**RESOLUTION APPROVING URBAN RENEWAL DEVELOPMENT AGREEMENT
WITH MARKET DISTRICT ONE, LLC TO DEVELOP CITY-OWNED PROPERTY AT
401 SE 6TH STREET AND 400 SE 7TH STREET IN THE METRO CENTER URBAN
RENEWAL AREA, APPROVING CONCEPTUAL DEVELOPMENT PLAN, AND
SETTING PUBLIC HEARING ON VACATION OF
ADJOINING CITY RIGHT-OF-WAY**

We have reviewed the first (1st) submittal of the site plan for the Connolly Lofts project, located at 401 SE 6th Street and 400 SE 7th Street in Des Moines, and have determined that the following conditions must be satisfied before plan approval can be granted.

CONNOLLY LOFTS
401 SE 6TH AND 400 SE 7TH

SITE SURVEY / DEMO PLAN

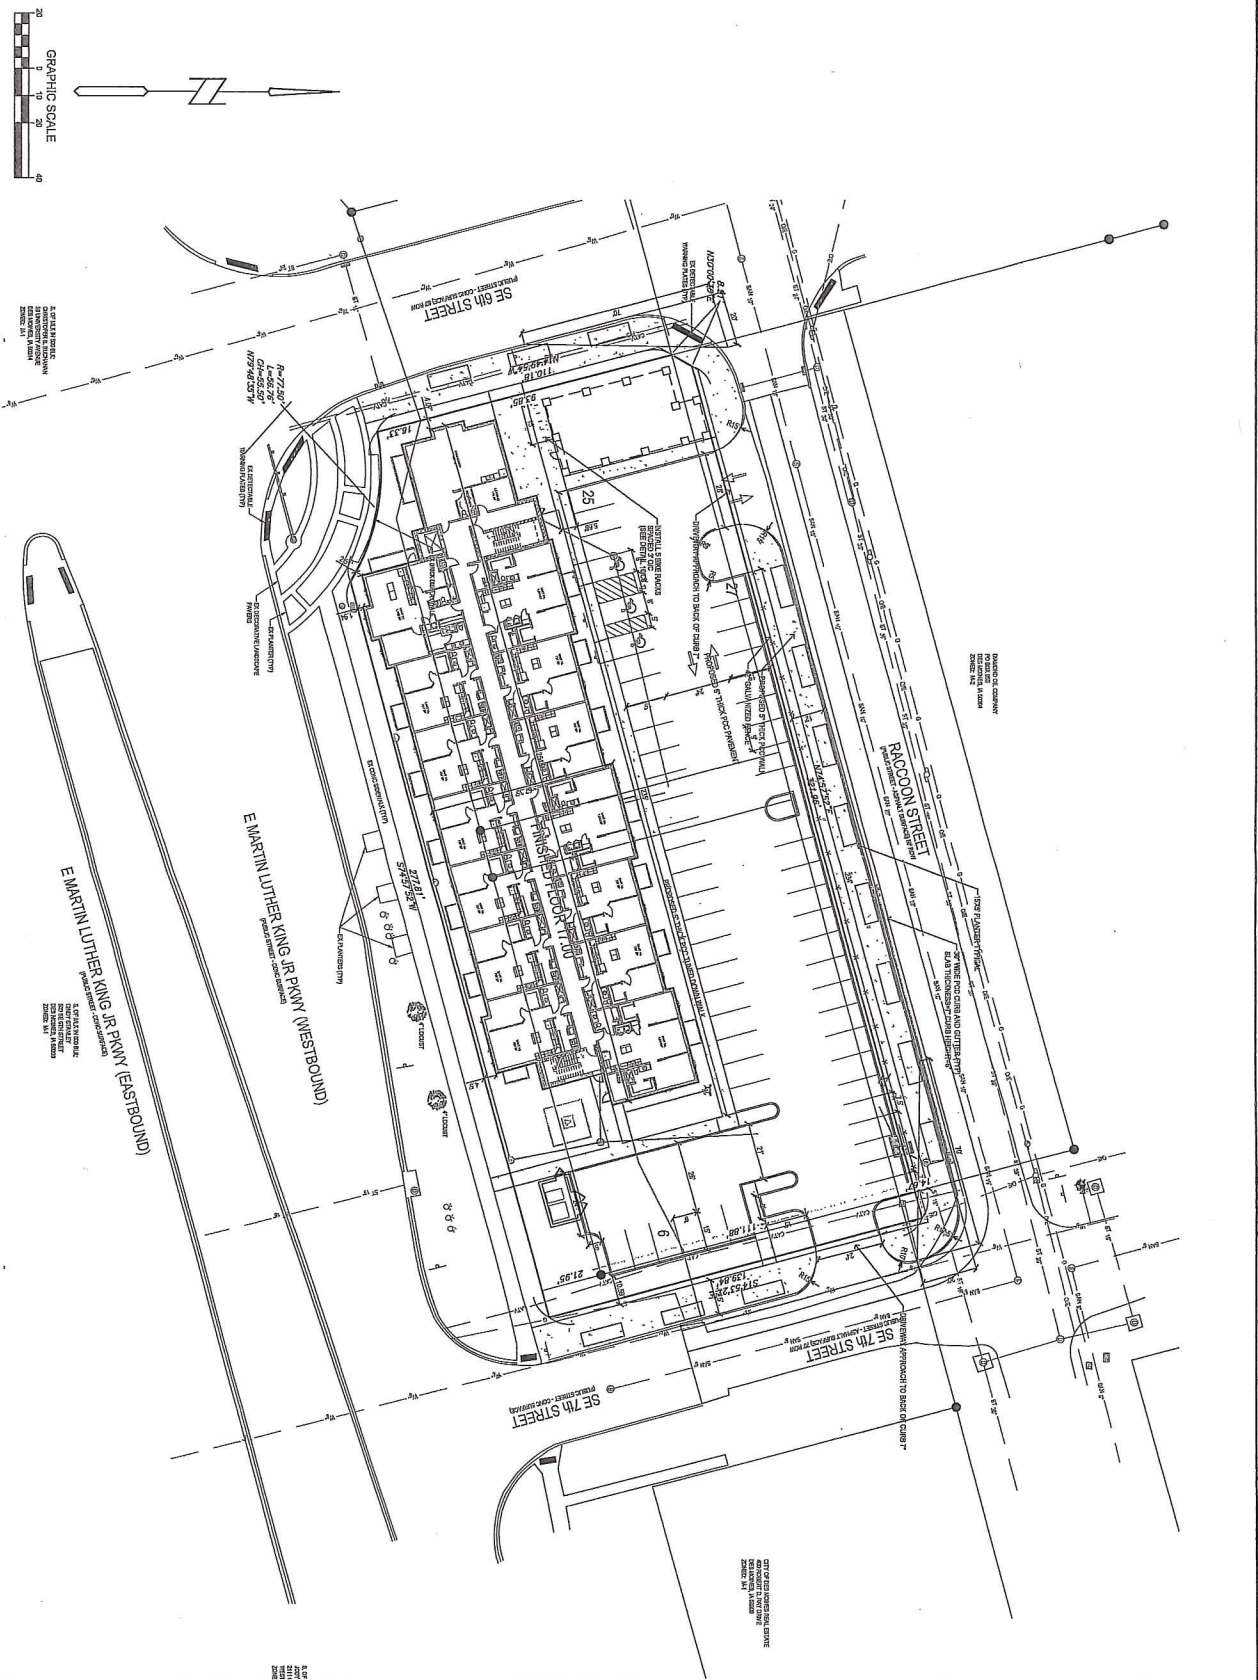
34. Provide protection plan for existing crabapple trees onsite. Provide a diagram of tree protection measures on the site plan and identify the trees to be protected.

35. Per the Municipal Arborist, a tree moving plan, detailing methods and warranties, will be required for the seven (7) honeylocusts trees onsite. As part of the transplanting, replacement trees will be required along the southern border of the development and those trees should be specified at a minimum 3" dbh. Contact the Municipal Arborist (283-4105) for potential moving locations.

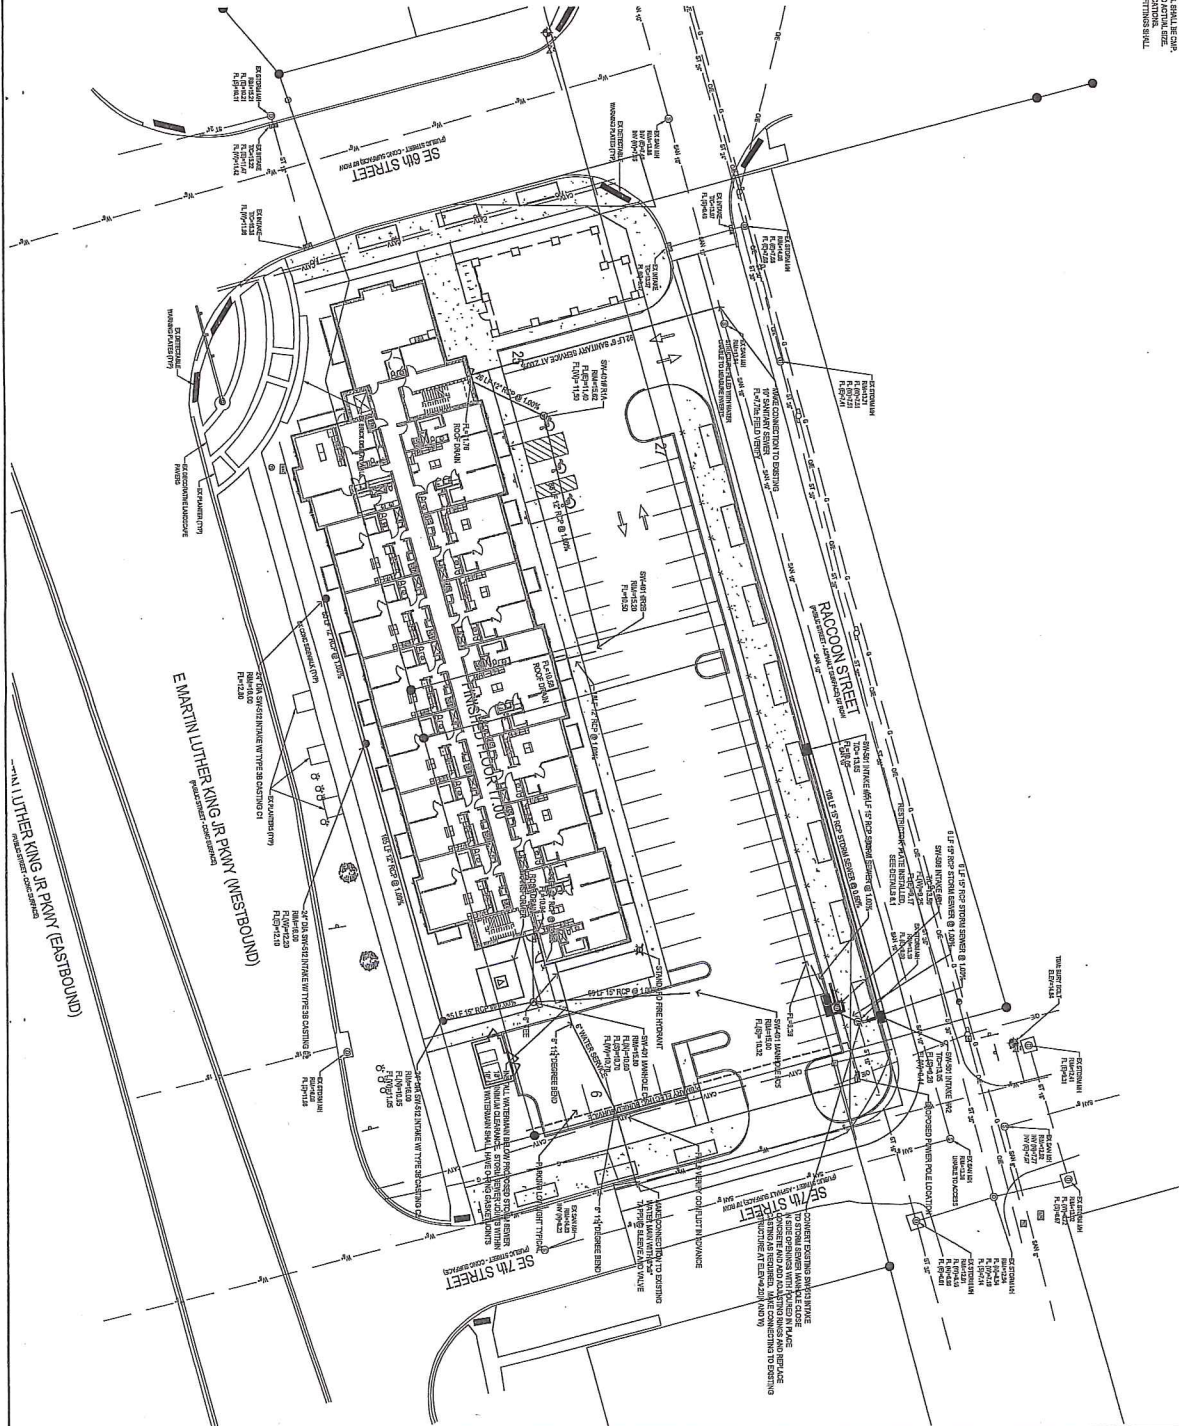
19. The beginning of a driveway approach curb opening must be at least 5 feet from the end of the intersection radius. Show dimensions to demonstrate that this requirement is met.

21. Show a 20' x 70' vision triangle, measured from the curb, at each of the Raccoon street intersections. No sight obstruction between 2 and 10 feet high is allowed in this area.

40. Revise note regarding parking provided stating 52 stalls. Site plan shows 56.
